F PLANNING REPORT

Belvor Close, Spalding, Lincolnshire. PE11 3FZ

Planning Reference H14-0391-21

Erection of chill store, collation, loading dock together with offices, self store containers and car parking.

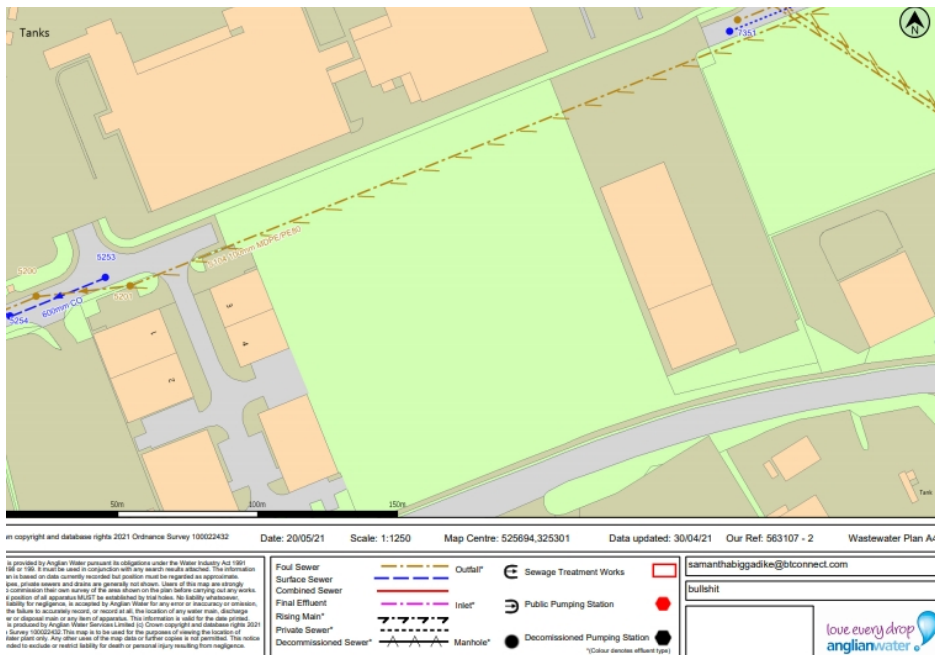
Section1 Assets there are AWA crossing the site and there are assets running close to the site which will be taken into account during the works. Should any unknown assets be found during the work AWA will be consulted accordingly. Below are the asset maps we have taken into account during our site planning.

Note the blue diagonal line is an abandoned pipe

Pump main as shown on our drainage plan

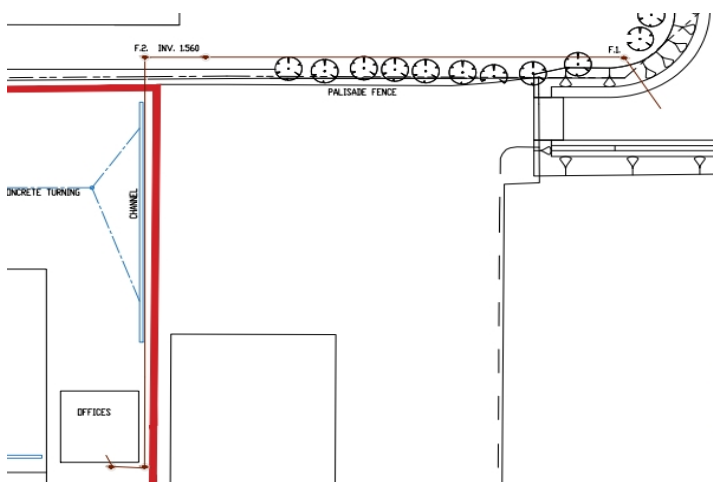
Section 3 used water network, AWA state that they have used :- application form, location plan, flood risk assessment and design access statement for making their assessment and further comment there is insufficient information clearly they should read the site plan and the drainage plan provided with the application.

AWA have not in our view undertaken a topo survey or made any assessment on the provision of foul water drainage. We have on the other hand have done so and there is sufficient private foul drainage on the site which connects to the AWA foul sewer in Platts Close.

The Manhole existing (private) F2 inv 1.560 ODN shown on our drainage plan ultimately connects (Private) F1 inv 1.150 ODN on a lateral provided as part of the Platts Close adopted sewer development.

Our floor level is 3.150 ODN with an in pipe gradient of 1:85 we can provide gravity fall for the proposal.

Pedestrian routes

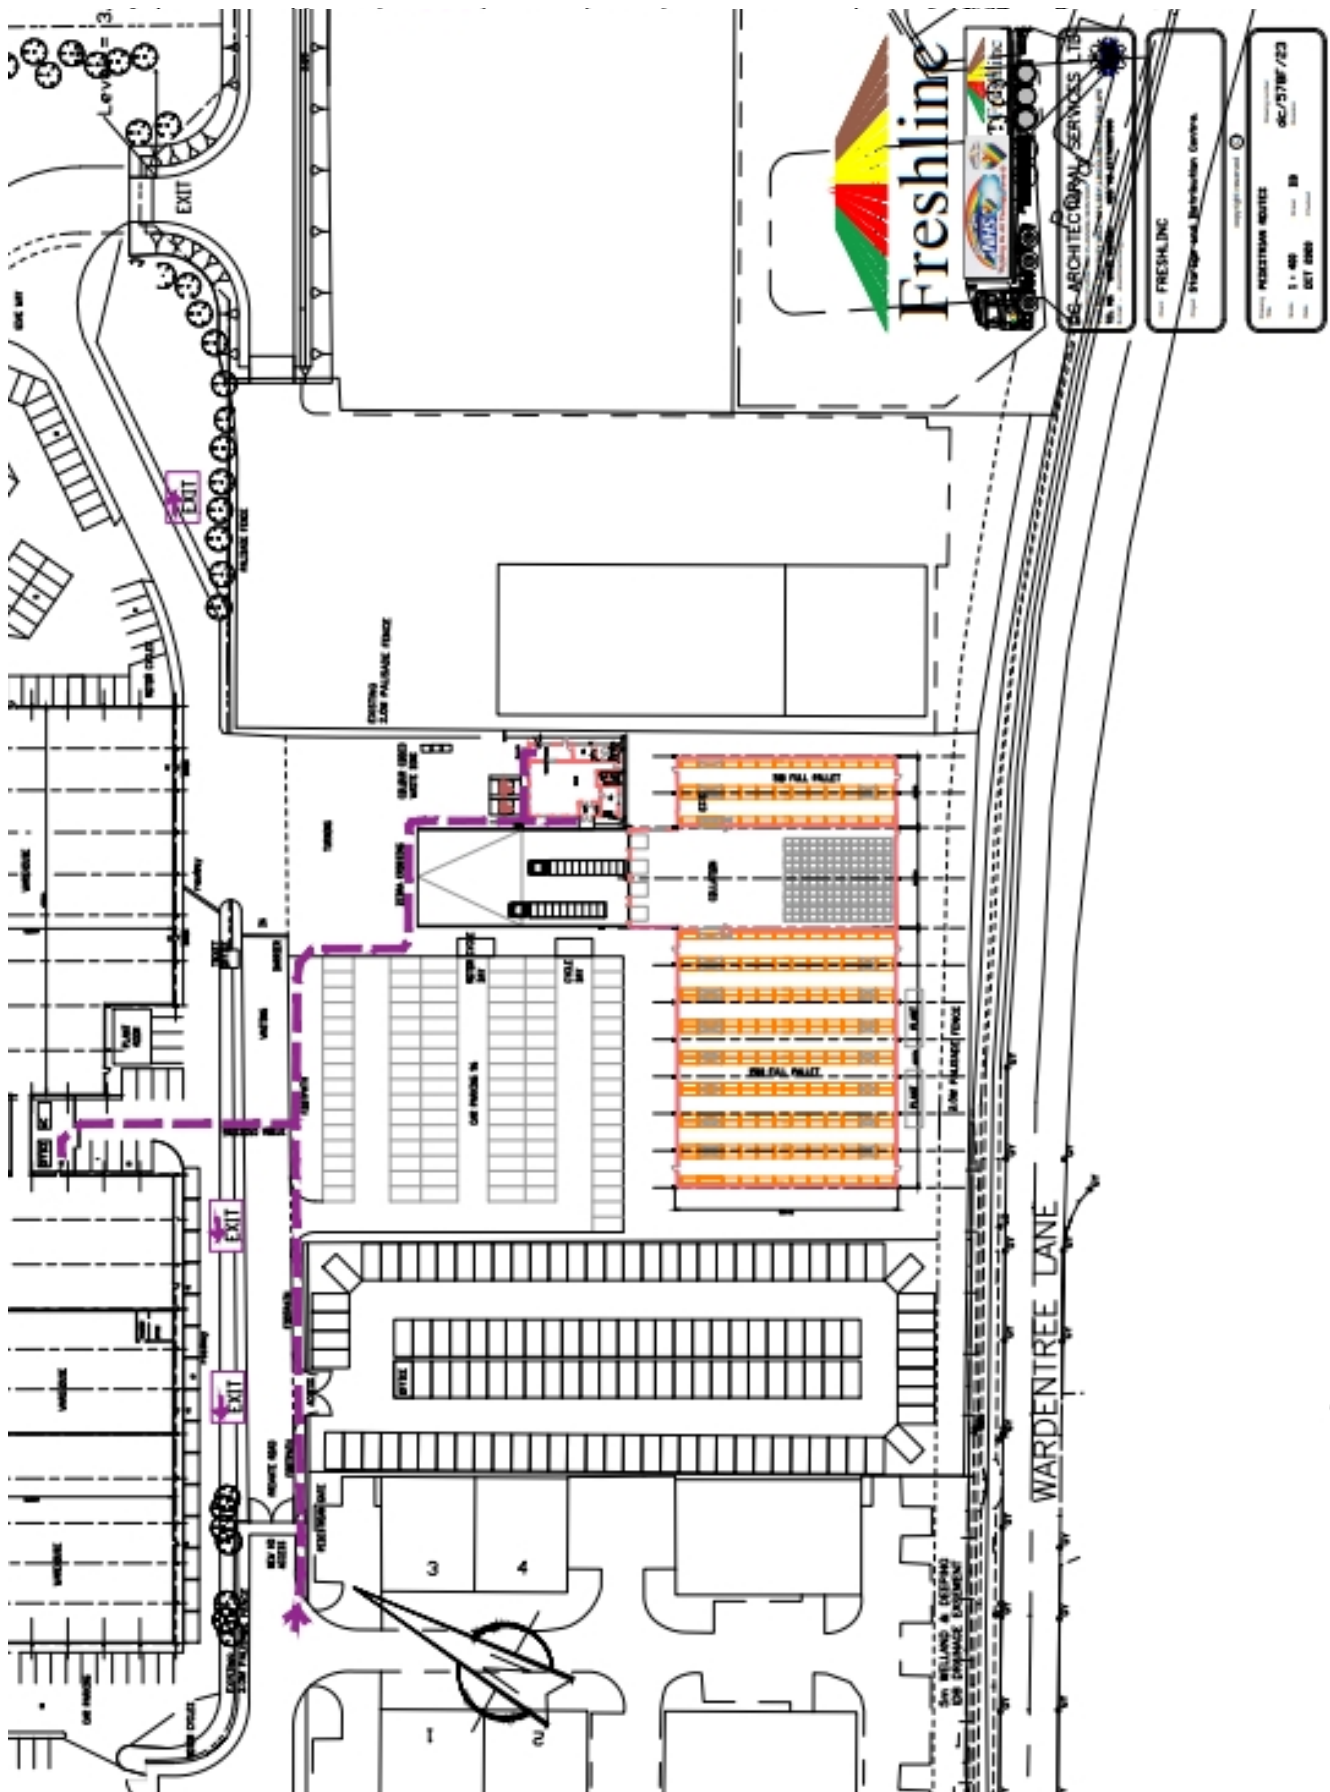
- The locked gate ? there has been no decision to lock or not lock the gate, the lock does not form part of our proposals
- We have considered vehicle movements at length at our board level pre- planning meetings as transport operators this is important part of the site planning, we attach below copies of our sketches used in this process although we do not anticipate they be part of the application as they may change. We will not be providing swept path analysis as experienced designers in this field and the vast experience of the professional client there is clearly adequate space allowed for operations.

- The car parking is, not surprisingly being provided for drivers.
- We will not be providing a separate application for containers.
- Please refer to our site plans and our plans above the is adequate parking within the container site for loading unloading and a pedestrian footpath linking the footpath on the highway to the container store and it continues on to and past the car park and to the office and chill store via walkways and controlled crossing points.

We note comments which we do not believe to be relevant to a planning application as such however we will comment and provide below our pre planning drawings which were used to formulate the overall plan, there are however subject to our Health and Safety Audit procedures and may change.
